marantz® SERVICE BULLETIN		Date: 8-Nov-2004	Model: SA8260, SA17S1
		Page: 1 / 2	REF.NBR: MZ04-080
Level		Application:	
★ ★		See below	
		Int.ref:

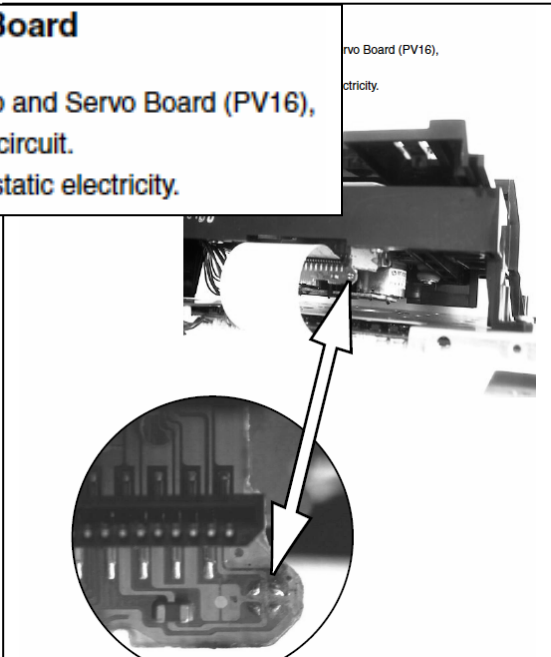
1. Can not playback Super Audio CD (low reflection DISC), "ERROR" is indicated on the display of the Unit.
2. Can not read TOC of low reflection DISC. The unit stops during playback Super Audio CD.

In order to keep HF level, about 2mA to 5mA of laser current is increased.

1. CHIP RESISTOR (**330 OHM**) is added to Laser pickup PCB.
